NOTICE OF MEETING

Planning and Environment Committee Meeting No. 7/14

Item		Page
1	CONFIRMATION OF MINUTES - Meeting held on 15 July 2014	1
2	288 ROWE STREET, EASTWOOD - LOT 27 DP 4826 Development Application for erection of a new dual occupancy (attached). LDA2014/0171.....	5

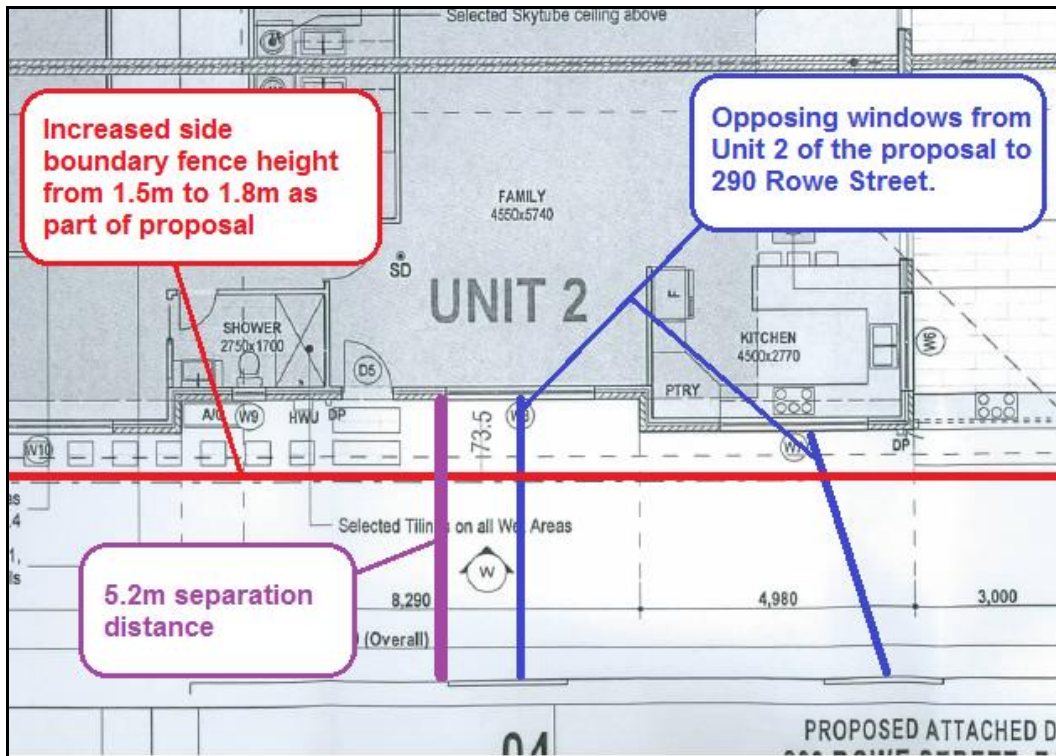
Comment: The windows are considered to be offset an appropriate distance (approx. 5.2m – see **Figure 4** below) from the neighbouring windows and private open space areas at 290 Rowe Street. Combined with the screening effect of the side boundary fence, no unacceptable privacy impacts are considered to be raised with the proposed window locations.

Figure 5 – Diagram showing the effective height of the boundary fence in terms of its ability to reduce overlooking impacts, along with the window size, dimension and sill height of the kitchen window which would also reduce opportunity for overlooking to the adjoining dwelling at 290 Rowe Street.

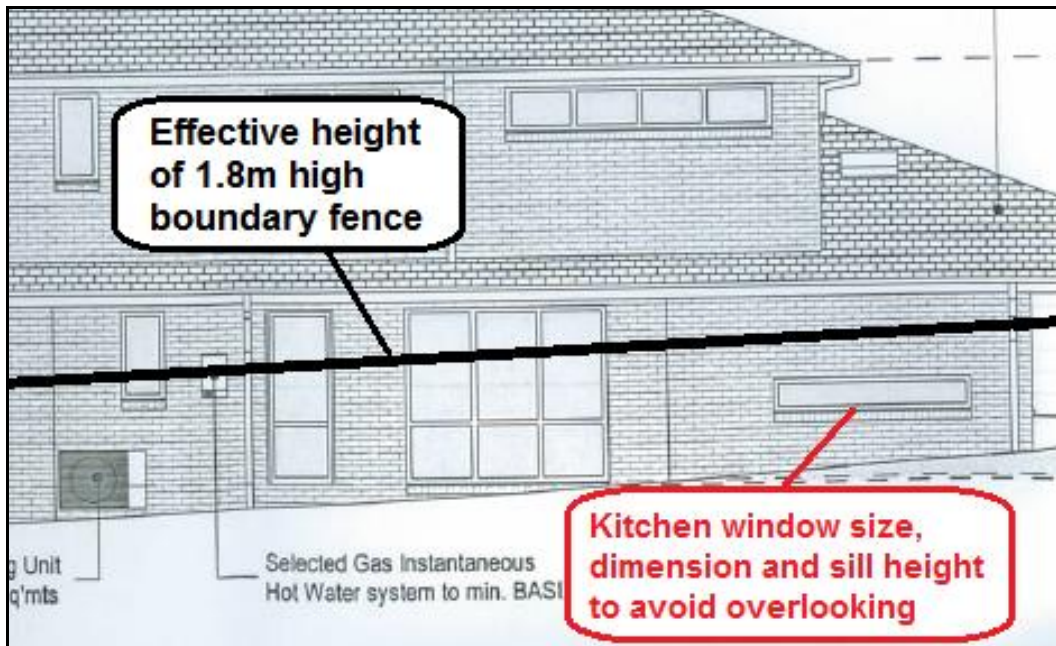
The opposing kitchen window to the dwelling at 290 Rowe Street is considered to be of a size and dimension, and also have a sill height that would restrict opportunities for overlooking. This is demonstrated in **Figure 5** below.

Figure 6 – Shown in this diagram are the small elevated front porches for each dwelling that have an area of only 4.3m². Adjacent to the front porches are the sitting rooms for each dwelling which also partially exceed the maximum level of fill under the Ryde DCP 2010.

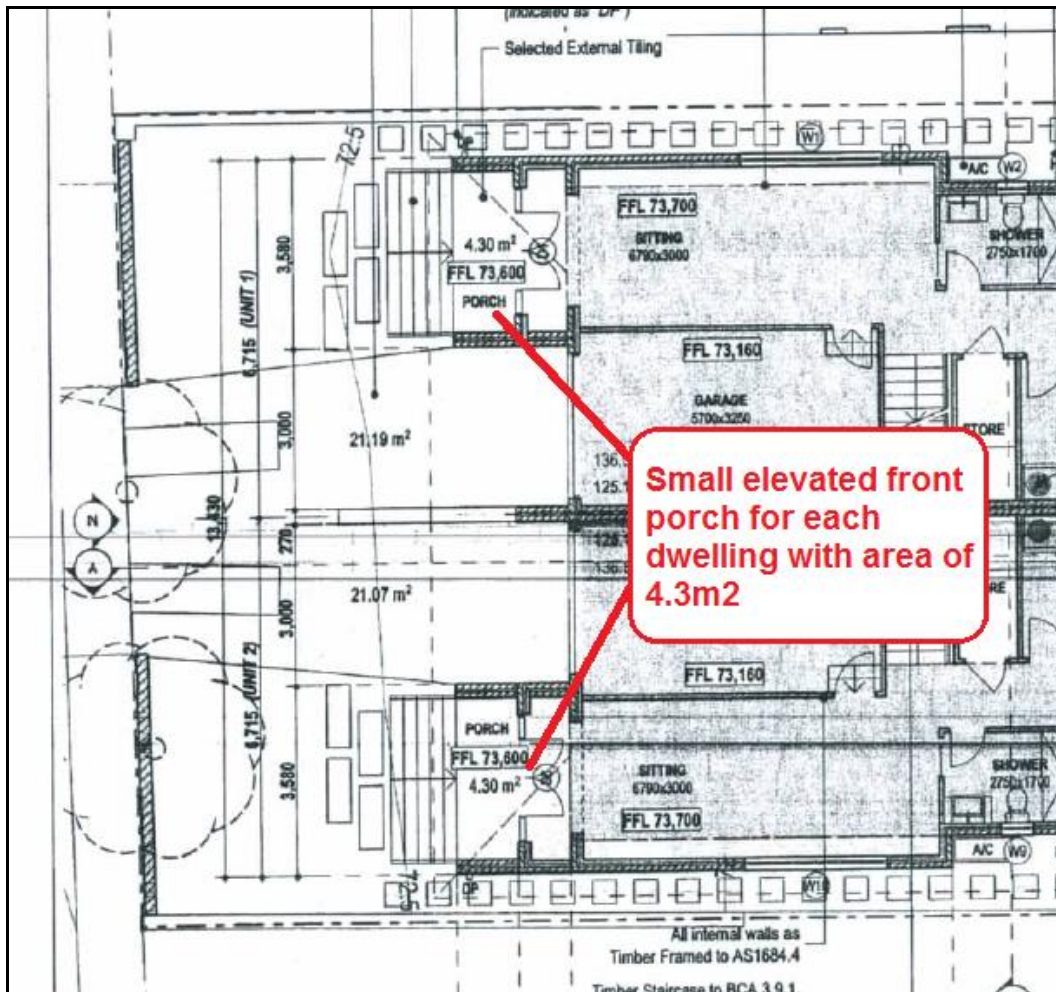
The raised northern elevation of the development proposes two small porch areas measuring 4.3m² each, for Units 1 and Unit 2 (see **Figure 6** below). These porches are considered not to be large enough for utilisation by the occupants as anything more than an entry/egress path to gain access to and from the dwellings. In addition the sitting room windows proposed to be located in the raised northern area of the development have been placed so as to minimise overlooking, whilst maximising solar access to the dwellings.

Figure 11 – Plan demonstrating proposed level of overshadowing at 9am on June 21. As can be seen the eastern facing side windows are overshadowed at 9am on June 21 (winter solstice).

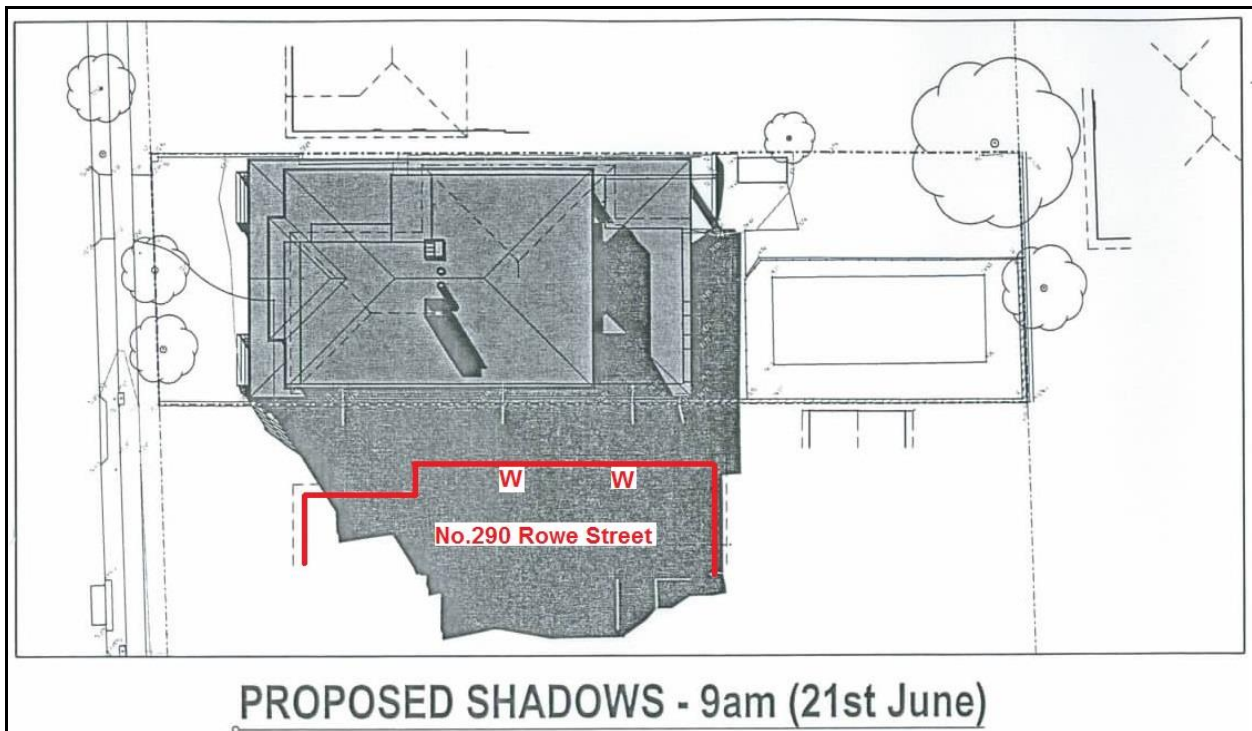
Comment: As demonstrated in the shadow diagrams submitted as part of the development application (refer to **Figure 11** to **Figure 13** below), the proposed development is shown to have some minor overshadowing impacts on the neighbouring dwelling at No.290 Rowe Street, Eastwood between 9am and 3pm during the winter solstice.

As outlined in **Figure 11** to **Figure 13** below, the shadow diagrams indicate that No.290 Rowe Street, Eastwood will be subject to some minor overshadowing to two (2) eastern facing windows at 9am on the 21st June. However, no overshadowing will occur after 12pm.

Figure 14 – Plan of proposed development and landscaping on subject site. Diagram shows the significant amount of deep soil area provided in the rear yard, despite not meeting the minimum 8m x 8m dimension outlined in the Ryde DCP 2010.

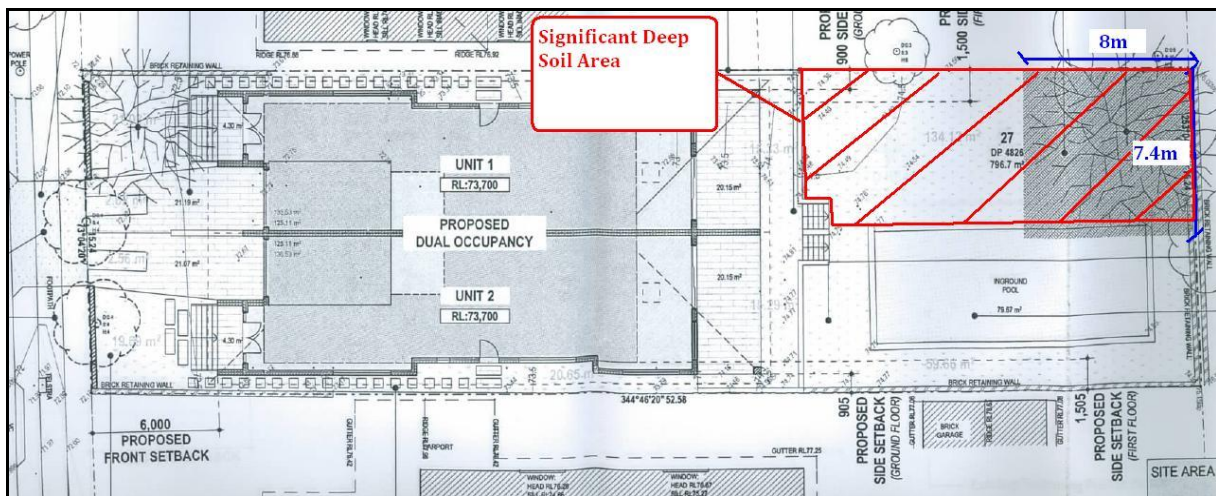
A review of the submitted plans indicates that the proposed development has a deep soil area of 28.56% (227.56m²) and does not have a deep soil area with minimum dimensions of 8m by 8m in the back yard. As such, the proposal does not meet the numerical controls outlined in Section 2.5.1(a) and (b)(i) above.

- The proposal includes the retention of an existing in ground swimming pool in the back yard. As a result, the minimum dimension of the proposed deep soil area is 7.4m (rather than 8m) as can be seen in **Figure 14** below.

Figure 15 – This diagram shows the proposed areas of cut and fill exceedence on the subject site. Noted is how these levels of exceedence are confined to only small areas of the overall building footprint toward the front and rear portions only.

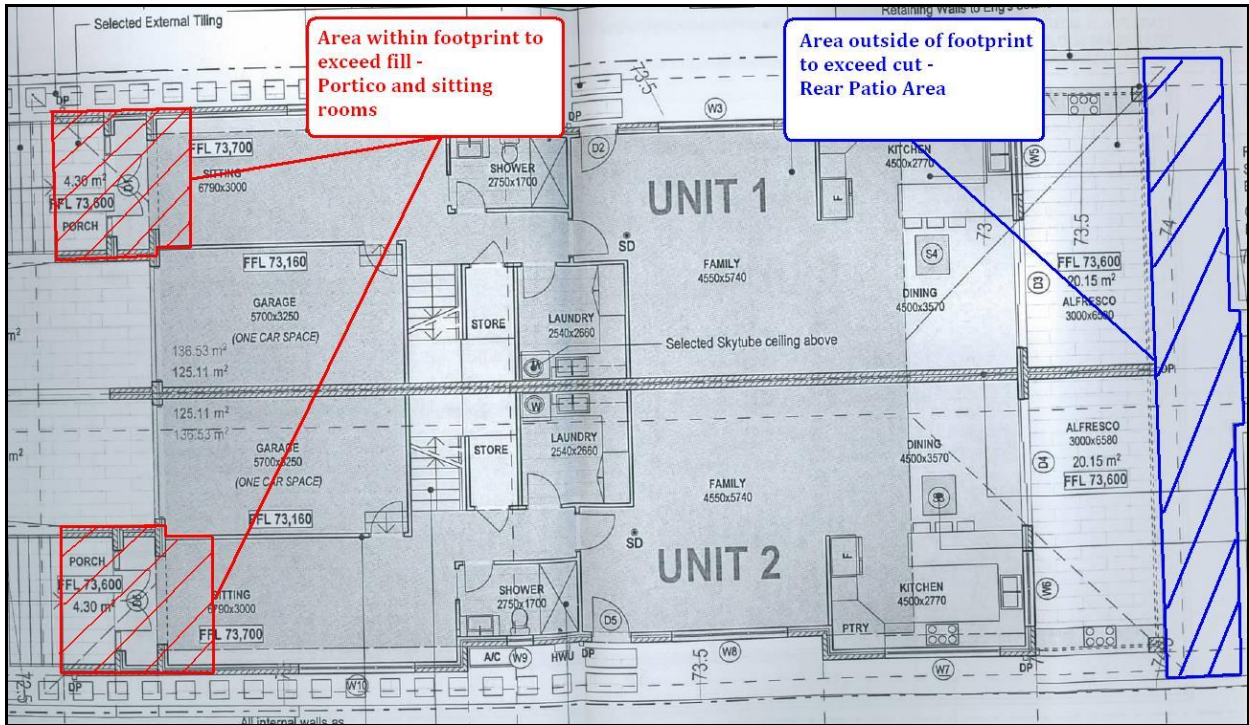
- As indicated in **Figure 15**, the maximum fill within and outside of the building footprint is exceeded along the front of the building where the entrance porches are, as well a portion of the front sitting rooms of both units. The extra height of fill in these areas will not result in a loss of privacy for neighbours as the porches are small in size with an area of 4.3m² and are oriented towards the street with walls on the sides. Moreover, the front sitting rooms are not considered to be the main living areas of the house and are not expected to be highly trafficked, beyond people entering and leaving the units.
